MEMORANDUM

SUBJECT: Zoning Commission Case Number 06-11F/06-12F, Setdown Report for The George Washington University Campus Plan Second -Stage PUD in Square 102

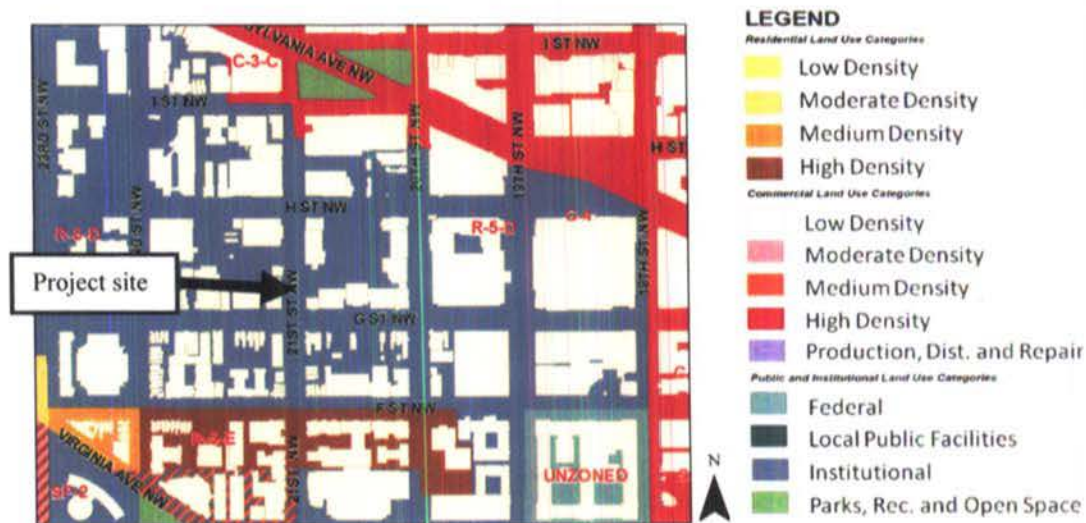
The University has provided an Annotative Site Plan (L-01) and a Planting Plan (L-02) to identify proposed landscaping and streetscape features. OP recommends that the University to provide additional information concerning the landscape plan along the building's 21st Street front, especially as it relates to the separation of pedestrians and loading vehicles.
